FINAL Environmental Impact Statement Resolution Copper Project and Land Exchange

Appendix R. Response to Comments Received on the DEIS

This document is a summary of public and agency comments received by the Tonto National Forest regarding the Resolution Copper Project and Land Exchange Draft Environmental Impact Statement (DEIS), and responses to those comments prepared by the Tonto National Forest. The comment period on the DEIS lasted from August 9, 2019, to November 7, 2019, with an extended comment period for Tribes ending on December 22, 2019.

Figure 2. Boundaries of affected Tribes' Aboriginal Territories overlapping with the RCM impact area.

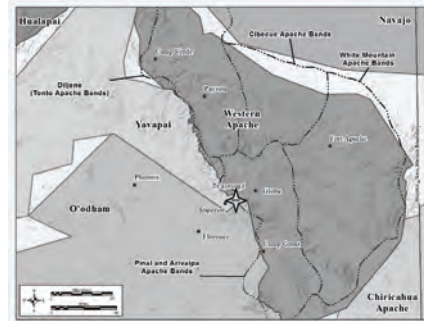
- A Figure 2 below is a higher resolution depiction of the aboriginal lands in the vicinity of the RCM project impact area.¹⁷ Figure 2 establishes that the DEIS proposed RCM project would have direct, indirect, and cumulative impacts on the aboriginal lands of Arizona's Apache, Yavapai, and Pima-O'odham tribes and nations.

Fig. 1 – RCM Pre-impacts

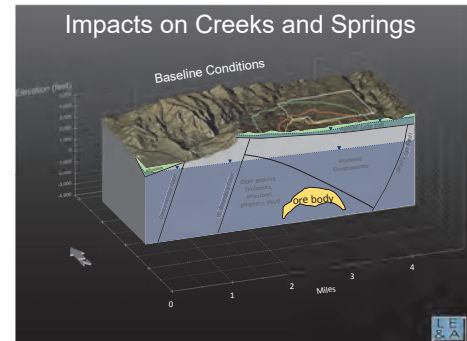
The RCM DEIS provides an inadequate evaluation of cumulative impacts on water resources in a region already experiencing shortages. The Arizona Department of Water Resources modeled the Pinal County water supply over a 100-year period, and shows an 8.1 million acre foot (“af”) deficit, one that does not include the RCM requirement of over 600,000 af over the 40-year life of the mine. That is enough water for 168,000 homes over 40 years. The Forest Service has not taken into account the effect of RCM’s water demand on the region or the Tonto National Forest itself. In effect, once mining commences, the region’s water supply will be immediately and irreparably compromised.

Comment ID: 30078-13
Response: WT4_A

Fig. 2 – Impacts of RCM Operation

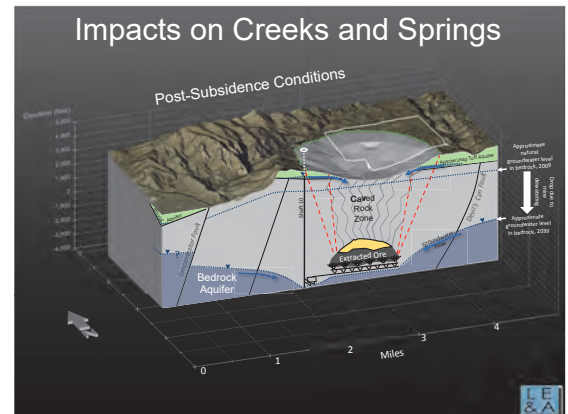
Comment ID: 30078-14
Response: WT42

As stated in the DEIS, “The deep groundwater system is being and would continue to be actively dewatered, and once block-caving begins the Apache Leap Tuff would begin to dewater as well.”⁷⁶

Fig. 3. USDA 100-year moisture index, showing much of Arizona has a moisture deficit, even when averaged over 100 years. Source, USDA, 2012, *Forest Health Monitoring: National Status, Trends and*

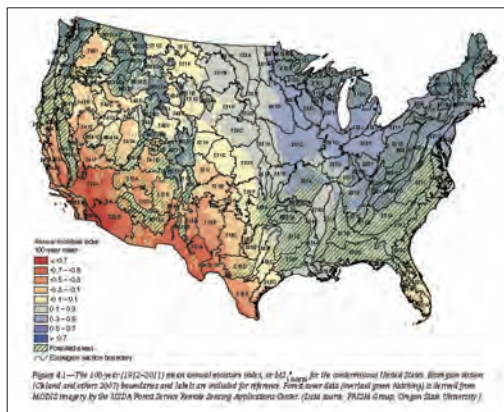
Tens of thousands of people in Pinal County rely on groundwater for their water supply and already, private wells are drying up.⁷⁹ As shown on Figure 3, the Forest Service’s own

research shows that Arizona has experienced moisture deficits even when averaged over the last 100 years.

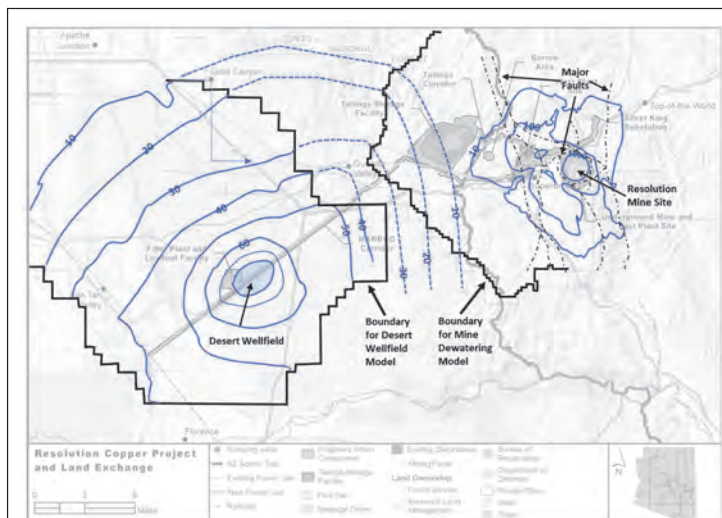
The analysis of water resource impacts in the DEIS is a segmented environmental analysis, which is improper under NEPA. In particular, by utilizing separate computer models and non-overlapping model domains, the Forest Service incorrectly isolated its analysis of mine dewatering from its analysis of hydrogeological impacts of pumping from the Desert Wellfield. Any effects of aquifer drawdown from the Desert Wellfield are not considered in the Mine Groundwater Model and *vice versa*. As shown in Figure 5, drawdown from these two pumping areas almost certainly overlap, thus rendering the isolated modeling analyses incomplete and inadequate for NEPA purposes. Resolution Copper constructed the groundwater models in such a way that cumulative impacts from the two discrete pumping areas are impossible to evaluate.

Figure associated with Comment ID: 30078-23

Figure 1: Cultural Resources Directly Impacted

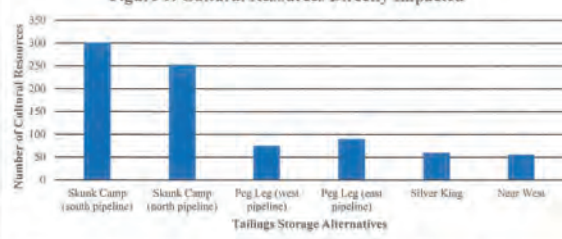
Regardless of the pipeline corridor selected, the Skunk Camp alternative will directly impact significantly more cultural resources, most of which are on State Trust lands. While the reporting of the Skunk Camp inventories has not been completed, the preliminary results given to the ASLD Cultural Resources Section indicate that almost all the cultural resources in the Skunk Camp alternative consist of Classic period Salado sites. Previous research in the region has revealed that habitation sites from this time period have the potential for large numbers of human burials (for example, partial excavation of Toiyagoge Pueblo near Top-of-the-World resulted in the recovery of 70 burials), and the numbers of sites in the Skunk Camp alternative suggests that several hundred burials could be impacted.
